Start of Sleep

Jim Graba

25 May 2016

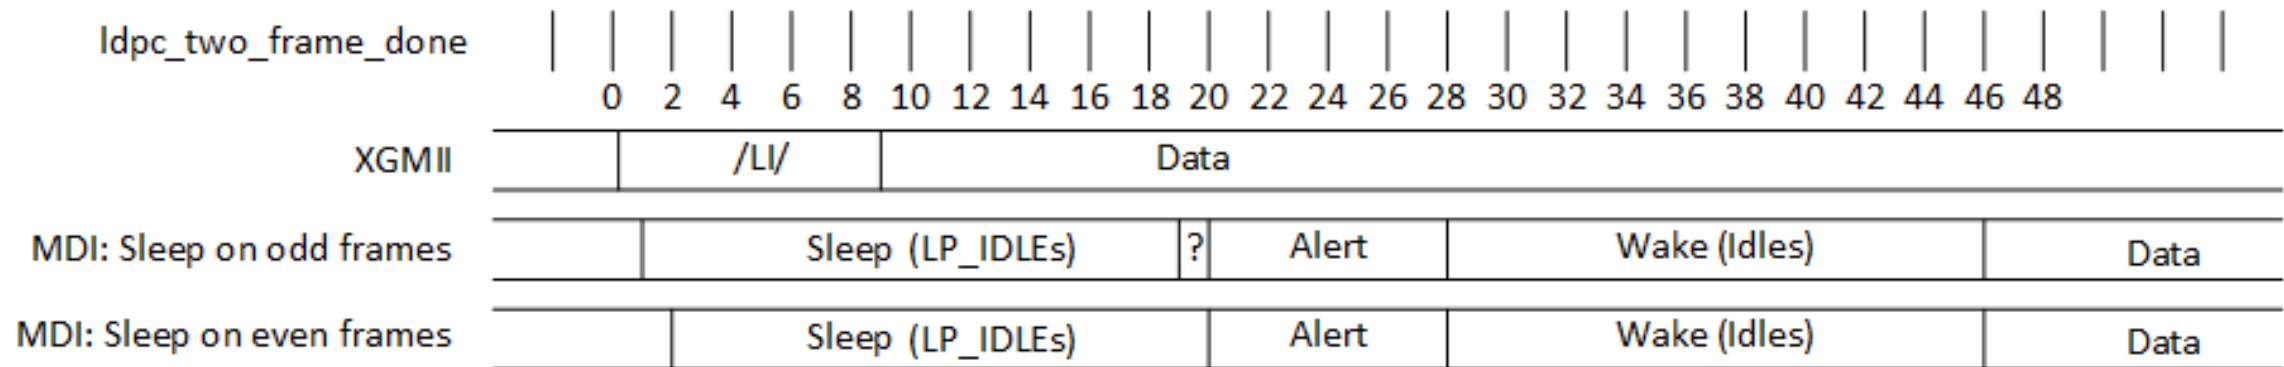
- Commenter Jerome Yu in comment i-54 pointed out inconsistencies in when Alert starts
- LPI events are intended to start and end on even LDPC frame boundaries
- Currently the description of Sleep on page 100 and the state diagram in Figure 126-18 allow for Sleep and Alert to transition on odd LDPC frame boundaries

- Accept comment i-54 including the proposed changes to Figure 126-18
- Change Sleep description on page 100, lines 2-6 as indicated in red: If the sleep signal begins on an **even** LDPC frame boundary, then it contains 18 full LDPC frames each composed entirely of LDPC encoded LP_IDLE blocks. If the sleep signal does not begin on an **even** LDPC frame boundary, then it contains one **to two** LDPC frames partially composed of LP_IDLE blocks followed by 18 LDPC frames fully composed of LP_IDLE blocks.
